DESIGN 	DRAWN BY 	DART AEROSPACE LTD HAWKESBURY, ONTARIO, CANADA	
CHECKED 	APPROVED 	DRAWING NO. DSI 9292	REV. A SHEET 1 OF 1
DATE 05.01.31		TITLE DOUBLER MODIFICATION	SCALE NTS
A	05.01.31	NEW ISSUE

DART SERVICE INSTRUCTION

TO AMEND INSTALLATION INSTRUCTIONS IIN-D412-698 REV. B OR REV. C

IT IS ACCEPTABLE TO PERFORM THE FOLLOWING DEVIATIONS WHEN INSTALLING THE D412-698-015 KIT ON 412CF AIRCRAFT:

SEE SECTION A-A OF FIGURE 4
ON PAGE 8 OF IIN-D412-698
FOR REFERENCE

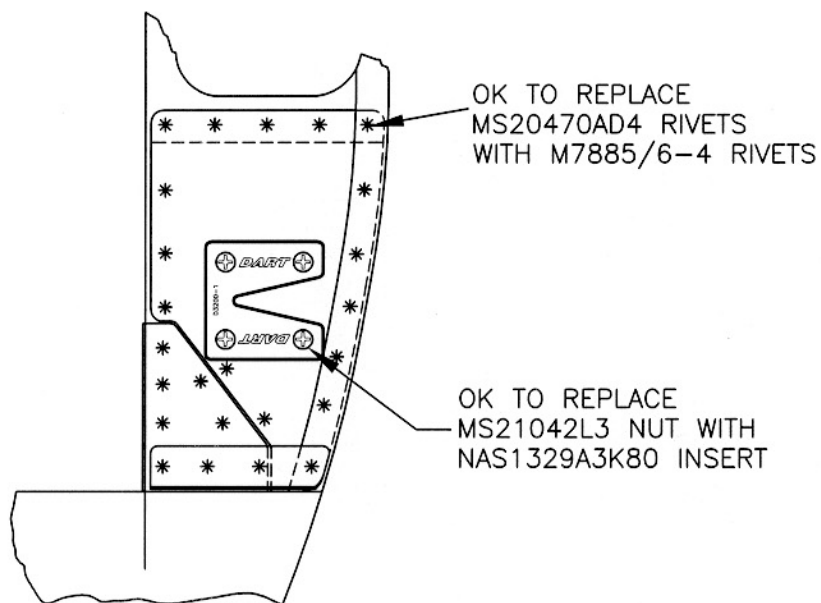
- 1) TRIM THE D3201-1 DOUBLER AS SHOWN BELOW TO AVOID INTERFERING WITH THE TRIANGULAR SHAPED DOUBLER ON THE INSIDE CORNER.
- 2) REPLACE MS20470AD4 RIVETS WITH M7885/6-4 RIVETS.
- 3) REPLACE MS21042L3 NUTS WITH NAS1329A3K80 INSERTS INSTALLED THROUGH BOTH THE D3201-1 DOUBLER AND THE EXISTING SHEET METAL IN THE DOOR POST. DRILL Ø0.250"-0.256" TO INSTALL NAS1329A3K80 INSERTS.
